UNITED STATES PATENT AND TRADEMARK OFFICE

Office Action Summary	Application No. 10/787,429	Applicant(s) RIPPOLONE, JOSEPH D.	
	Examiner William V. Gilbert	Art Unit 3635

DETAILED ACTION

Figure 5 from Bortugno

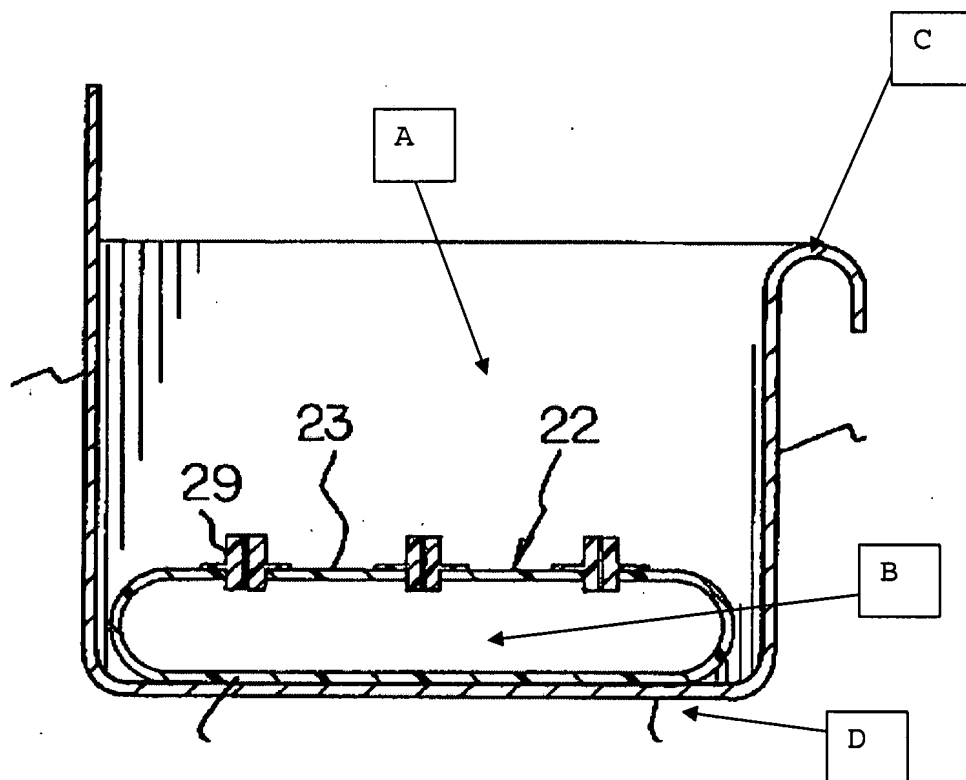
Independent Claim 12: Bortugno discloses a gutter section having a gutter section with a liquid passage (see "A" from attached Fig. 5 from Bortugno below) an air flow passage ("B" below), a gutter wall separating the liquid passage and the air flow passage, the gutter wall has two spaced apart side walls

(16) and a bottom wall (23) that define the liquid passage, and the air flow passage extends through the bottom wall (see portion 29 that extends through the bottom wall (23)). Applicant should respectfully note that the limitation "molded" line 1 indicates method steps and only the final product, the gutter section, is provided with patentable weight.

Claim 2: the air flow passage extends within the bottom wall (see portion 29).

Claim 13: the airflow passage is parallel to the liquid flow passage (see Fig. 5, generally).

Claim 14: the gutter wall is common wall (portion 23) that at least partially defines the liquid passage and the airflow passage.

Claim 15: the gutter wall (portion 16) includes a solid body extending between a continuous upper surface ("C" above) and a continuous lower surface ("D" above).

Claim 16: the air flow passage extends through the solid body (Fig. 2: proximate 17) and is spaced apart from the upper surface and lower surface (the lower surface should be noted as the "exterior portion" and portion 24 spaces the air flow passage from the support and lower surfaces.)

Claims 7 and 8: Bortugno discloses a gutter thawing system (Fig. 5) having a gutter section with a liquid passage ("A" above) and an air flow passage ("B" above) and a hot air supply (12). Bortugno does not disclose multiple of air flow passages or a multiple of gutter sections. It would have been obvious at the time the invention was made to a person having ordinary skill in the art as a matter of duplication of parts to have this limitation because duplication of parts has no patentable significance unless a new and unexpected result is produced. *In re Harza*, 274 F.2d 669 (CCPA 1960). See MPEP §2144.04. Further, Bortugno discloses the air passages as linear, but not
